OFFICE OF ENERGY INFRASTRUCTURE SAFETY

NOV_SCE_IAG_ 20211117-05

NOTICE OF VIOLATION

Report Name: IAG SCE 20211117-05

Structure ID: 4205199E

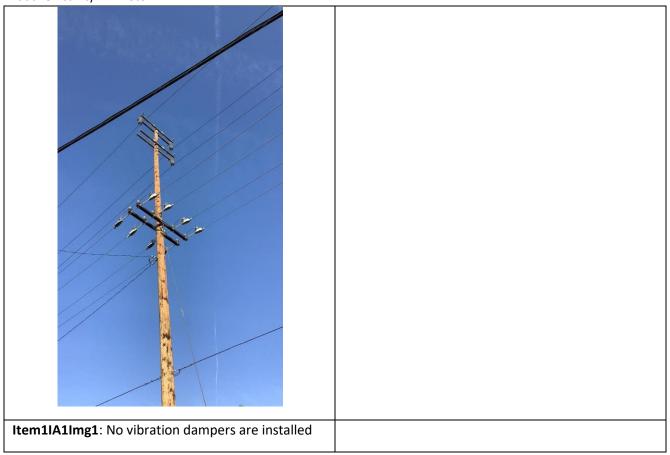
Item	Structure ID	HFTD	Initiative Number	Violation Type	Severity	Violation Description
1	4205199E	Tier 3	7.3.3.3.1	Adherence to Protocol	Minor	Failure to install vibration dampers on a span

Per SCE's Distribution Design Standards (DDS), Distribution Overhead Construction Standards (DOH), when installing covered conductor, vibration dampers must be installed. Energy Safety staff found that vibration dampers were not installed at multiple structures where covered conductor was completed. The structures missing vibration dampers where covered conductor was installed are identified in Table 2 above. On November 19, 2021, SCE submitted a memo to Energy Safety titled, "Interim Deviation from Standards on Vibration Damper for Covered Conductor" (hereafter, "Memo"). This Memo was dated August 18, 2021, and indicates that due to supply chain issues, SCE will suspend the installation of vibration dampers until December 31, 2021. Because the covered conductor installations inspected by Energy Safety were completed prior to the issuance of the Memo and SCE informed Energy Safety of this supply chain issue only after inspections commenced, Energy Safety finds that SCE is in violation of its protocols requiring the installation of vibration dampers as part of covered conductor installations.
